1617 S MERIDIAN
PUYALLUP, WA 98371

STORMWATER PLAN

C4.0

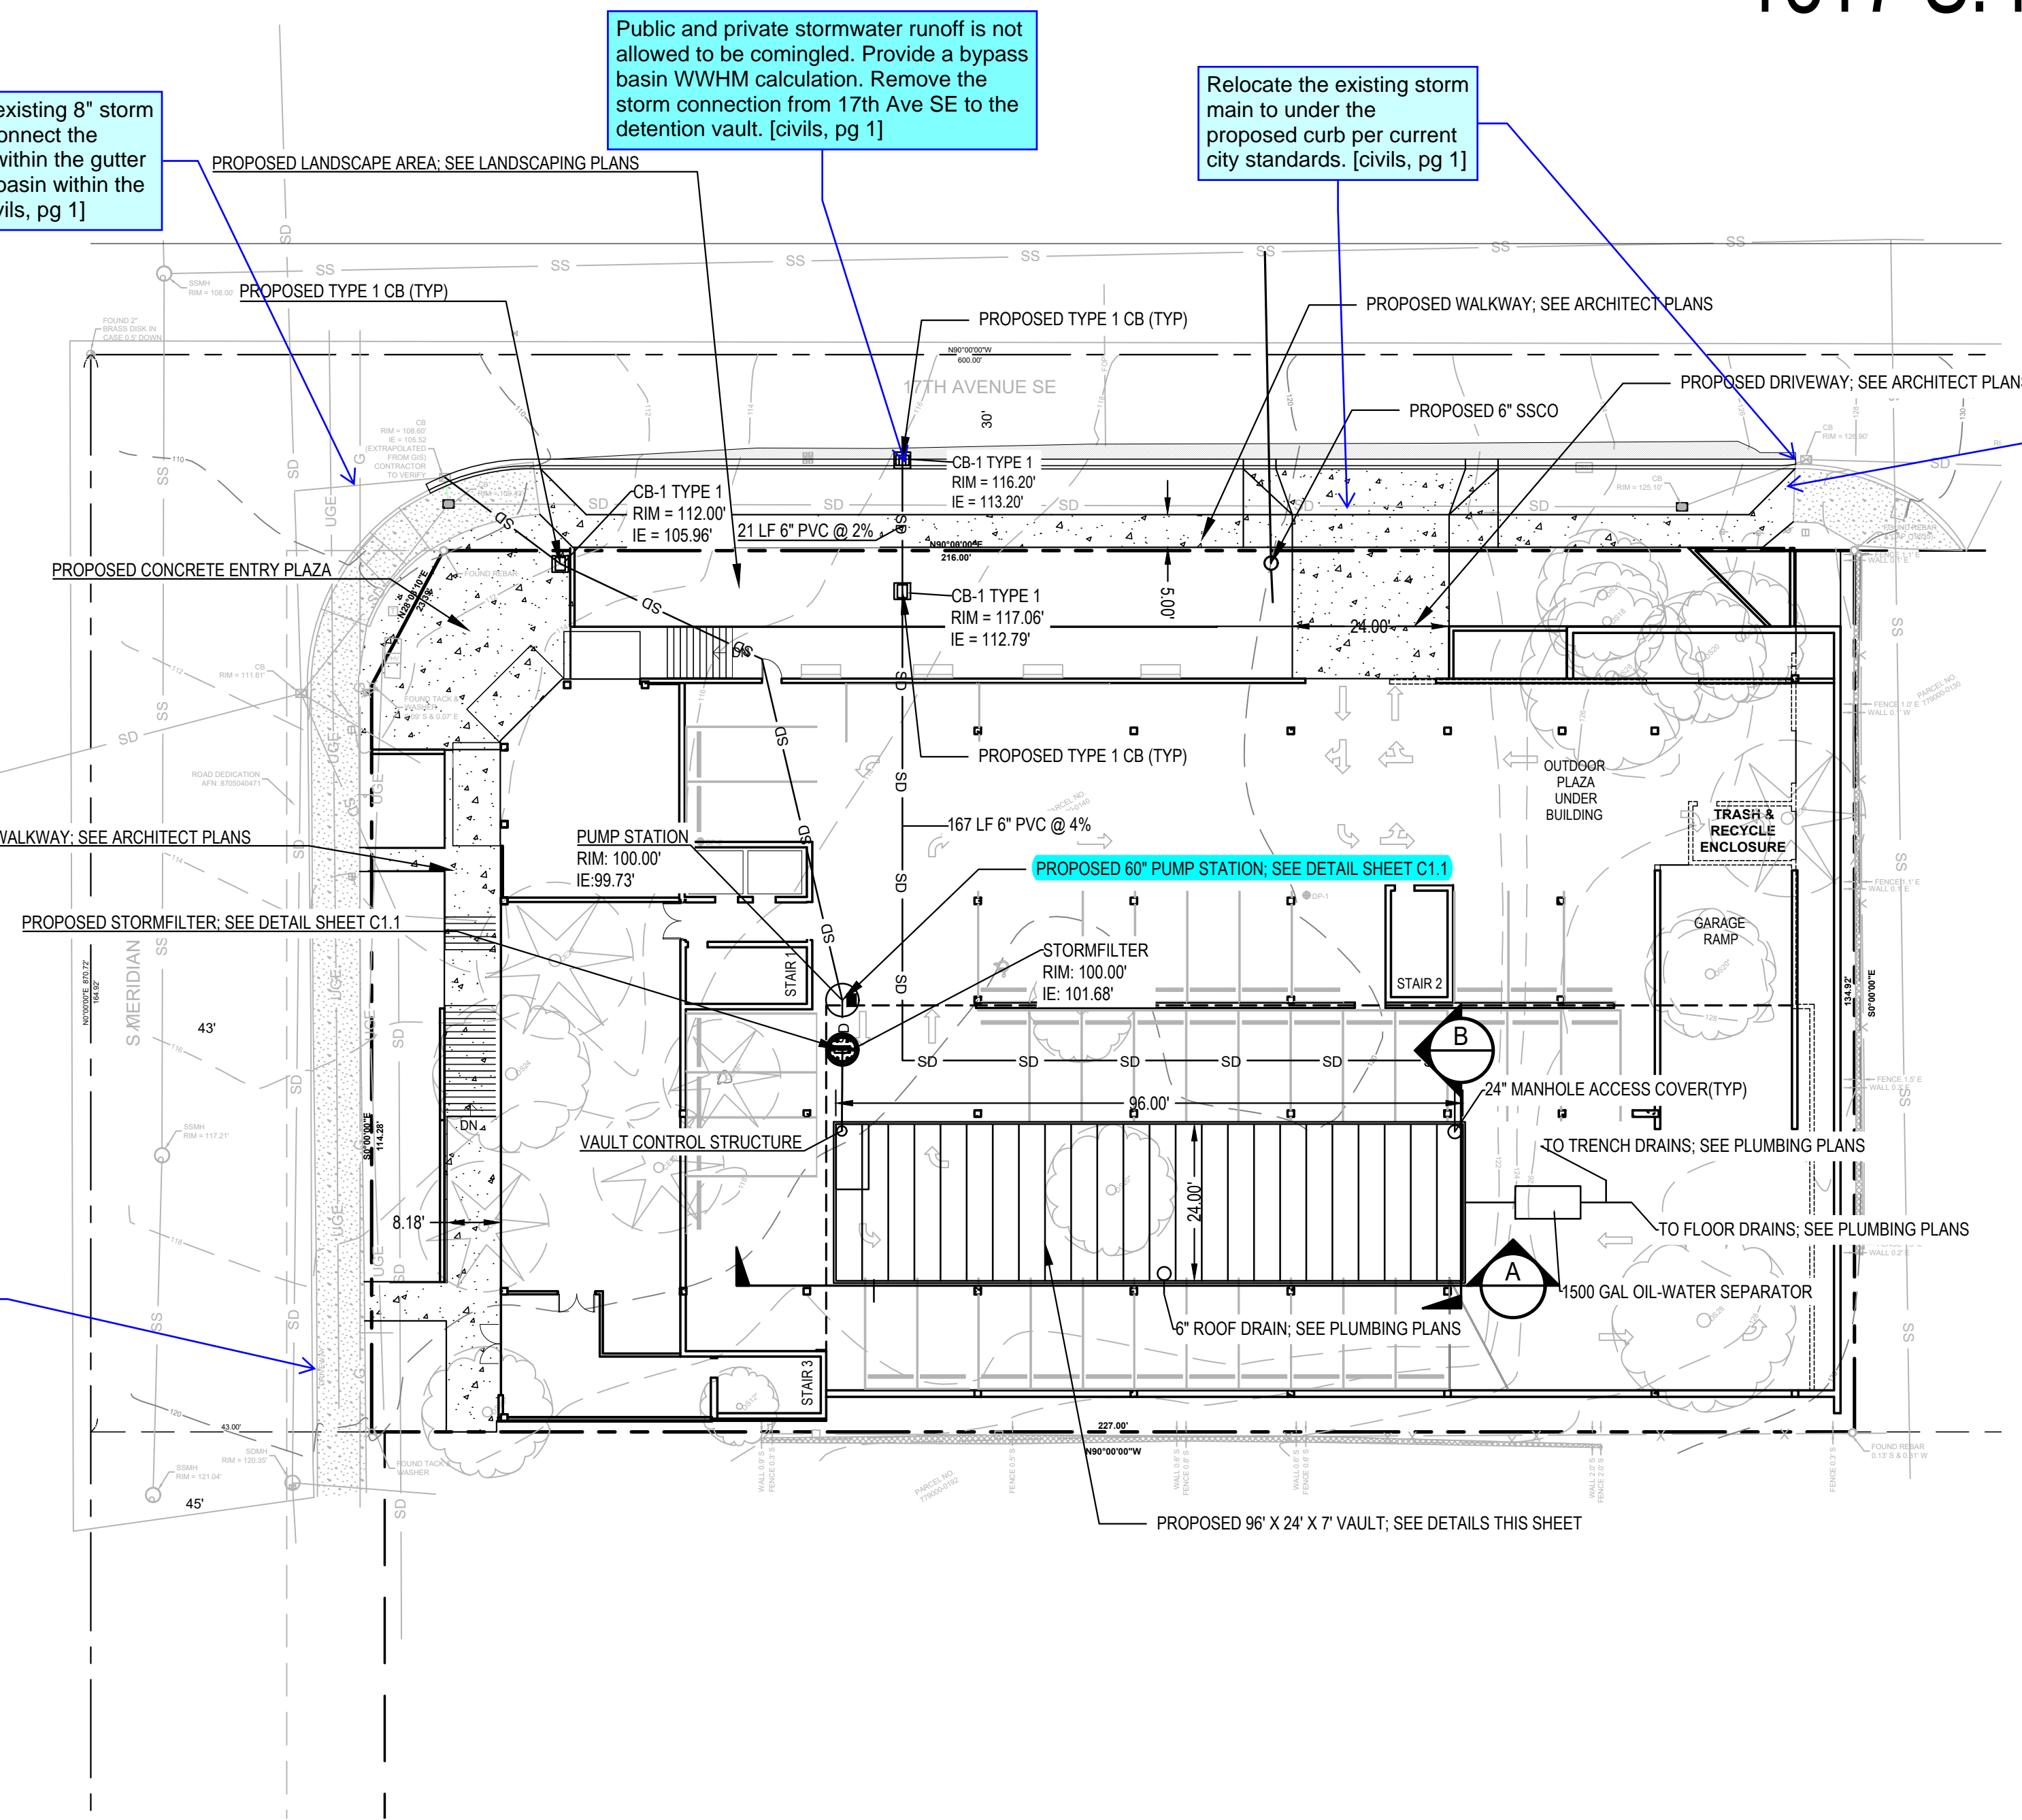
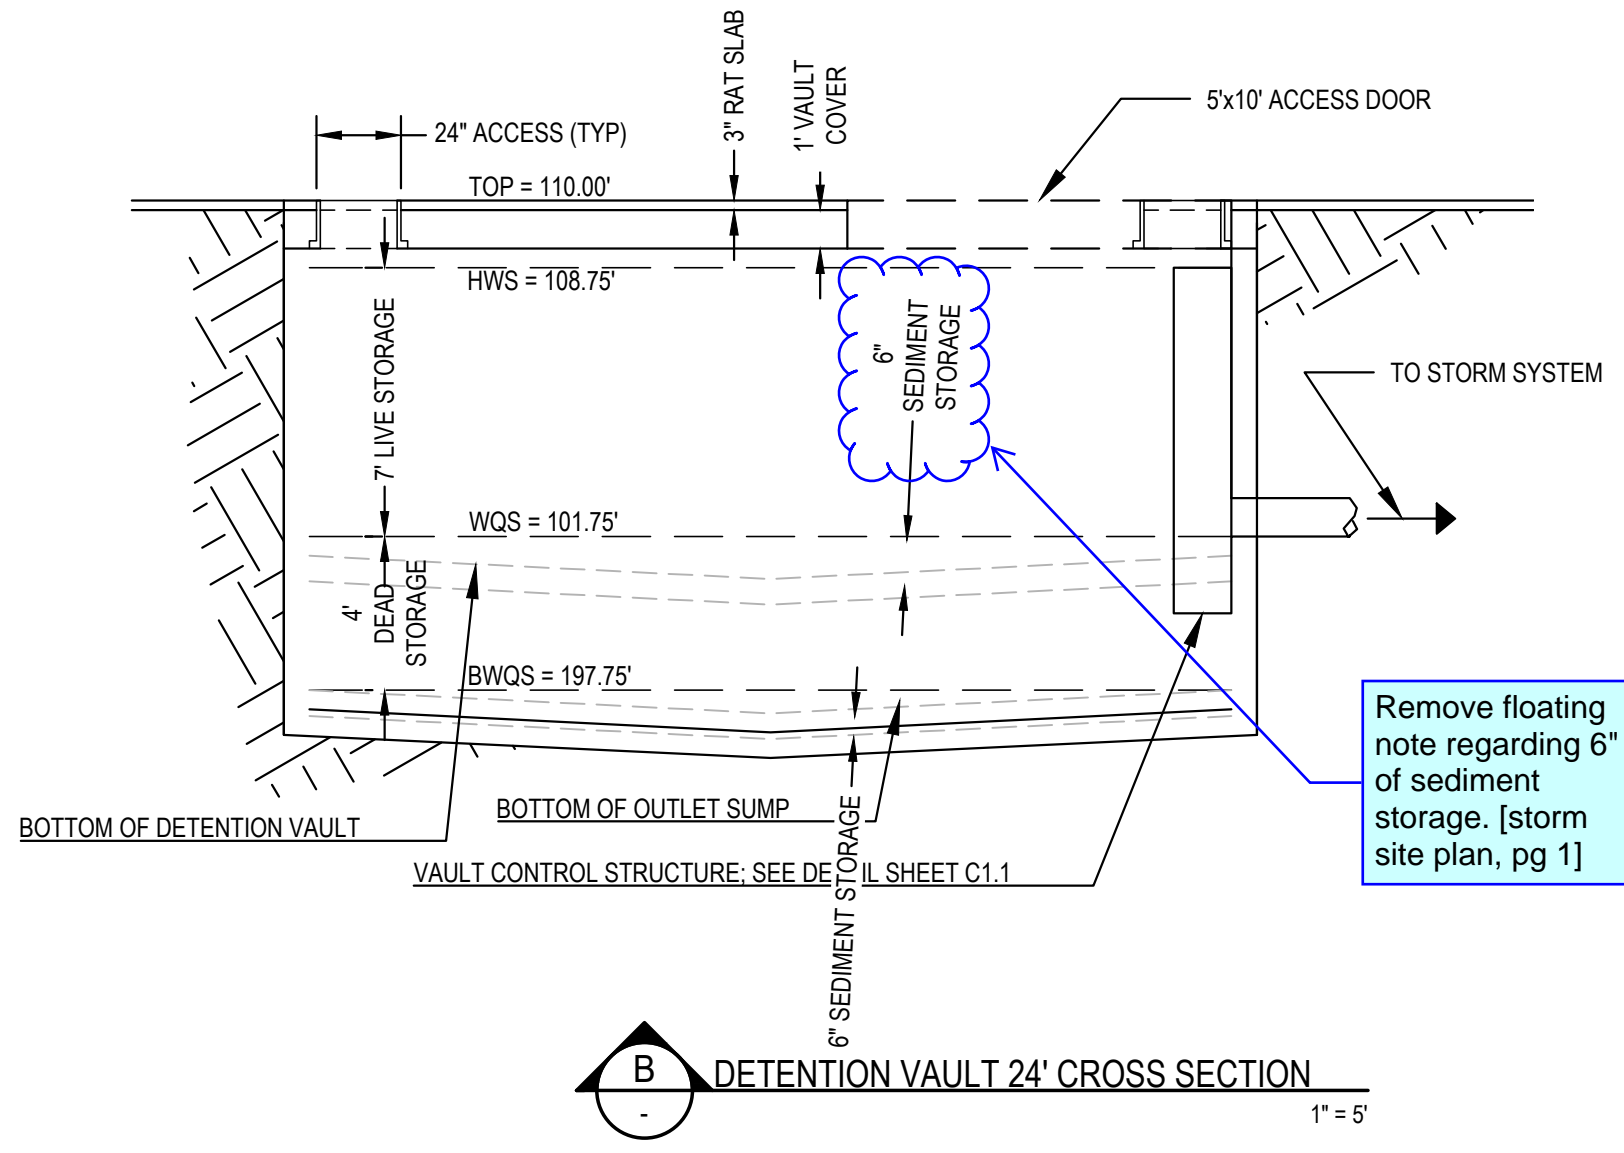
Provide a wetland report for the off-site wetland. Be sure to include the wetland category and habitat score. [civils, pg 1]

Cut/cap the existing 8" storm line and re-connect the catch basin within the gutter to the catch basin within the sidewalk. [civils, pg 1]

Public and private stormwater runoff is not allowed to be comingled. Provide a bypass basin WWHM calculation. Remove the storm connection from 17th Ave SE to the detention vault. [civils, pg 1]

Relocate the existing storm main to under the proposed curb per current city standards. [civils, pg 1]

Provide 12' walk with 4' street tree cutouts along 17th Ave SE. [civils, pg 1]

Make a note to remove the existing driveway cut along South Meridian. [civils, pg 1]

Remove floating note regarding 6" of sediment storage. [storm site plan, pg 1]
